Re: Albion Park Quarry – Stage 7 (SSD-10369) RFI - 11 November 2022

I refer to the Department's Request for Information RFI 2 dated 11 November 2022 in relation to further visibility matters for the above proposed development. The following provides a response prepared by Cleary Bros and RWC to both matters raised. The additional information requested is highlighted in *italics* with the response in a normal font.

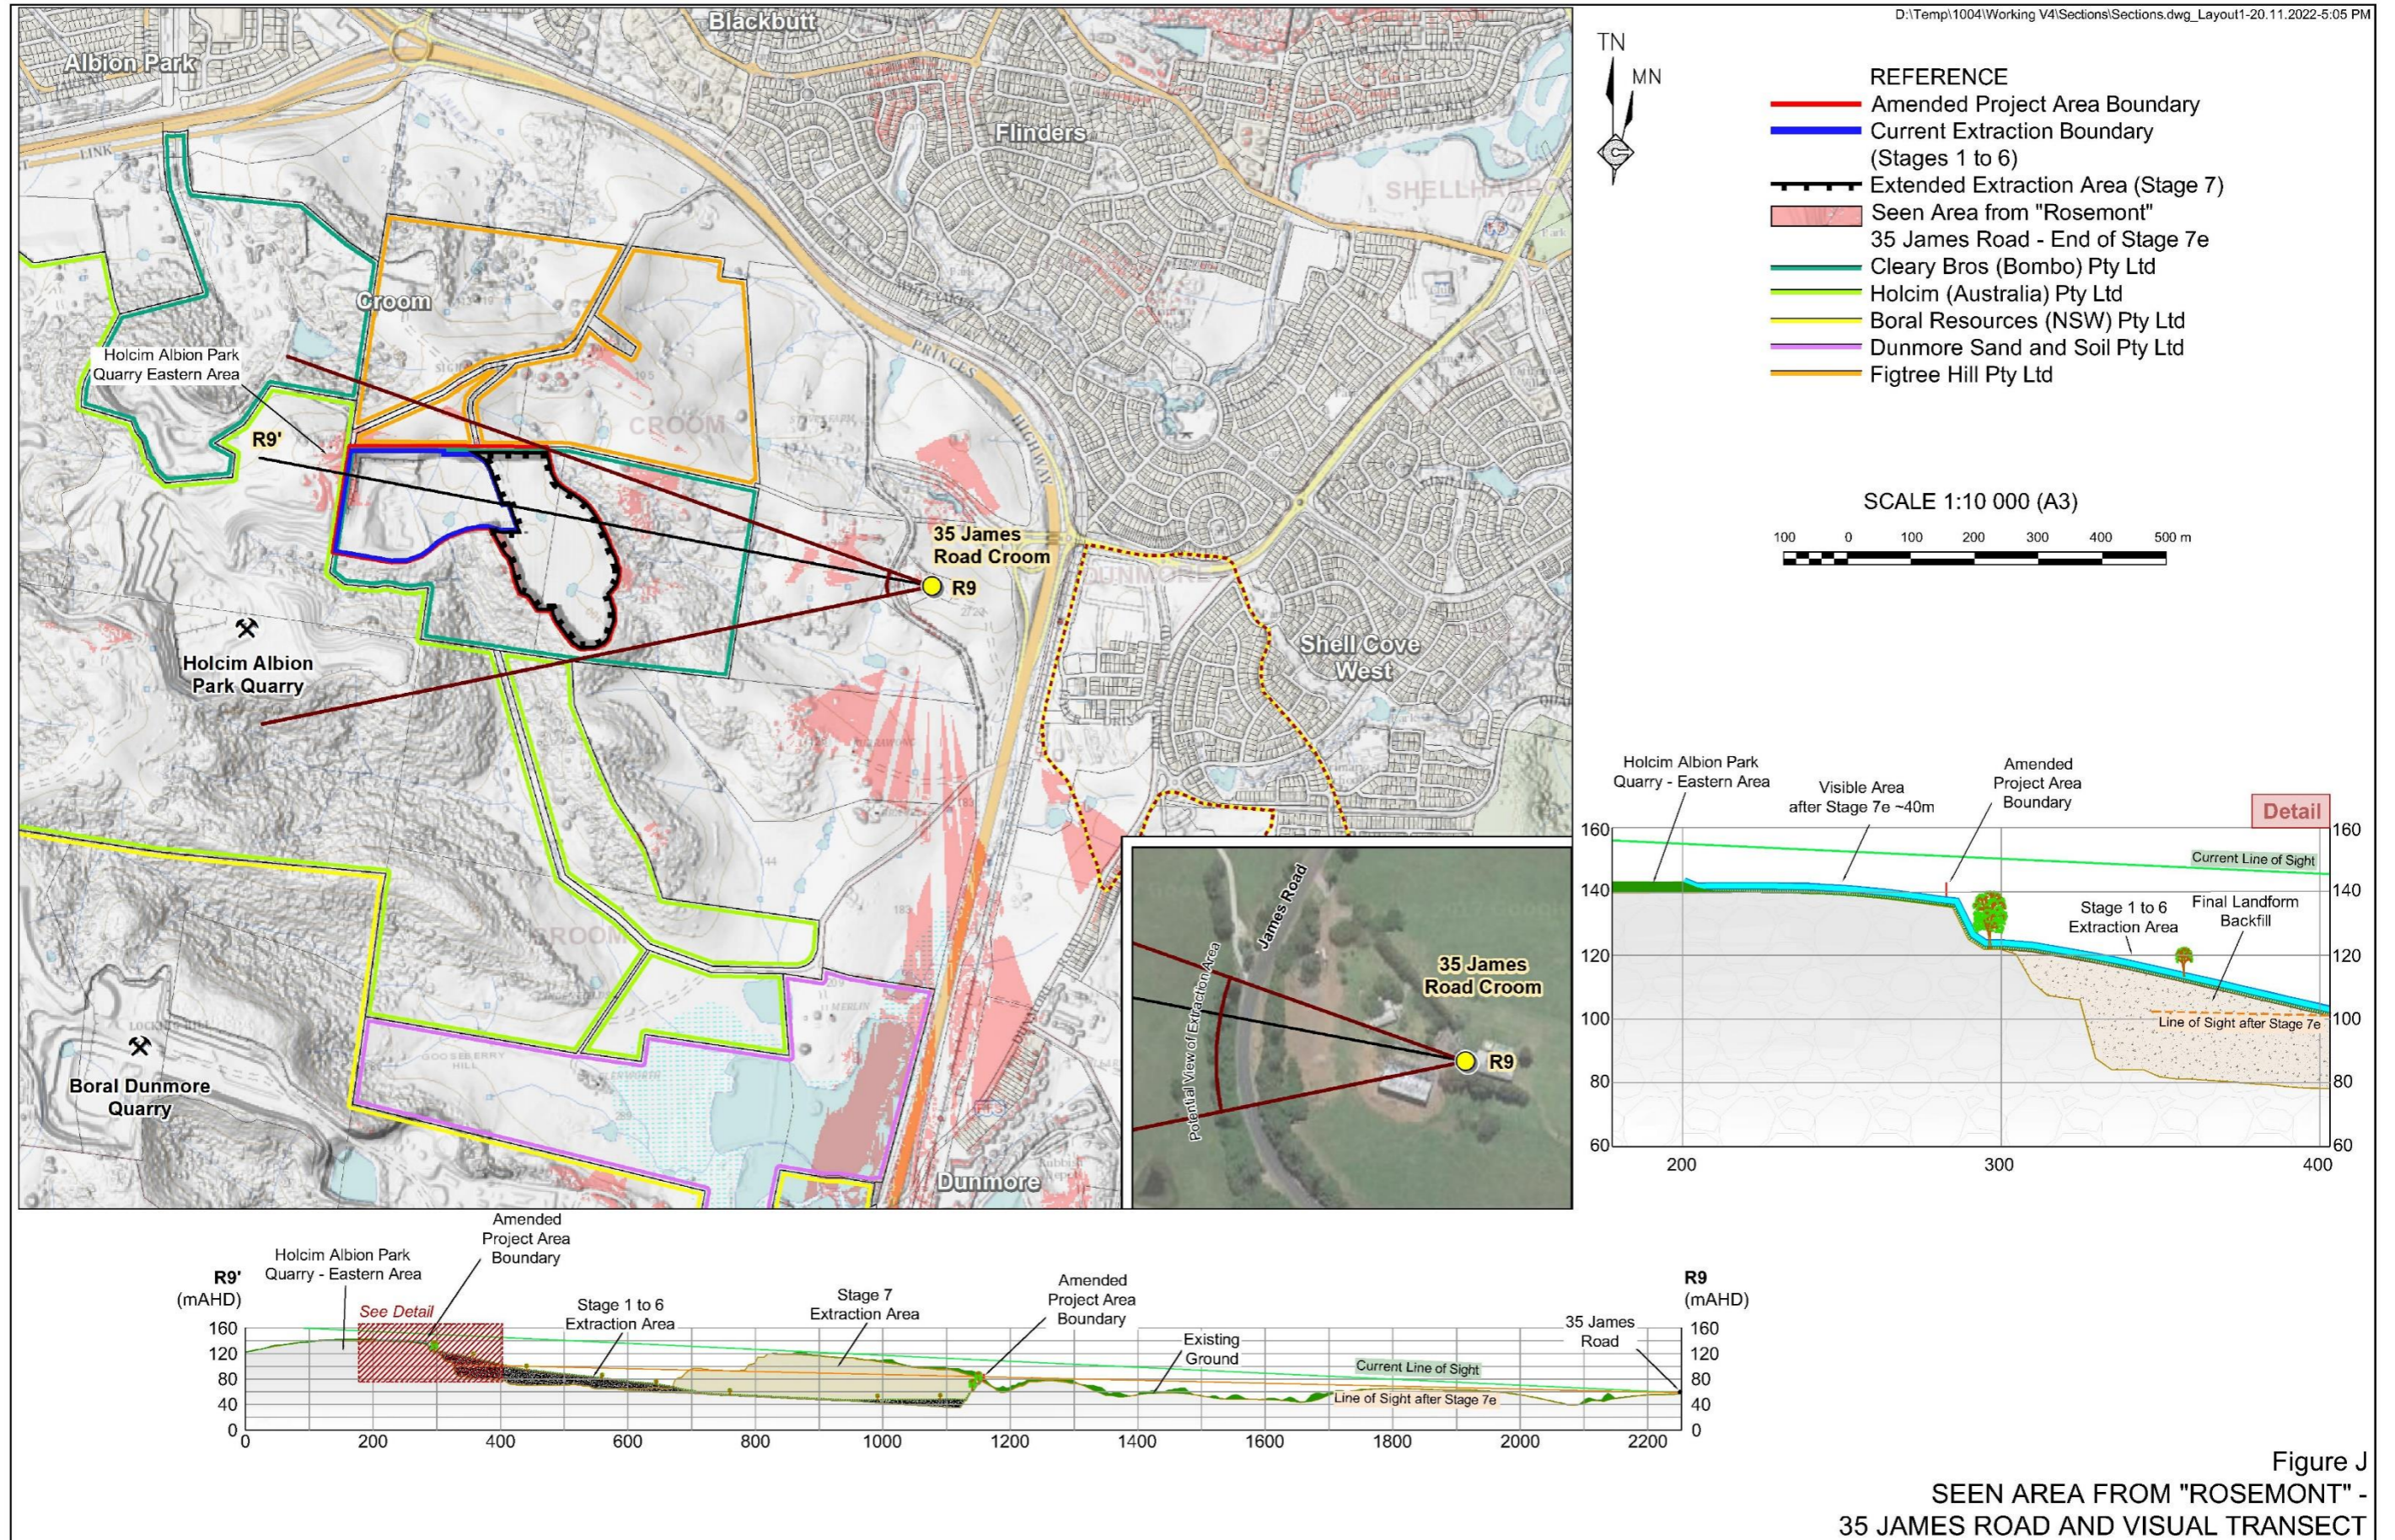
Submit a visual transects demonstrating the views from homesteads listed as heritage items under the Shellharbour Local Environmental Plan 2013, including:

- “St Ives” – 2 James Road Croom (Residence 4)
- “Rosemont” – 35 James Road Croom (Residence 9)
- “Kurrawong” – 126 James Road Croom (Residence 6)

- “Rosemont” -** The cross-section from “Rosemont” shown on **Figure J** identifies that the Stage 7 Extraction Area is currently visible from the residence. In the short term, i.e. for the first half of the Project life, the amenity barrier and tree screen on the eastern side of Stage 7a would visually shield the activities/operational extraction area from “Rosemont”. Following extraction of Stage 7e, the seen area analysis identifies that the northwestern corner of Stages 1 to 6 would be visible from “Rosemont”. The extent of visibility is displayed on the cross-section which shows a vertical distance of approximately 40m of the final vegetated landform in Stages 1 to 6 would be visible from the residence. The nature of the view from “Rosemont” would be similar to that displayed in **Figure F** from Site 5, with the exception that the section of the Stages 1 to 6 revegetated final landform that would be visible would be smaller.
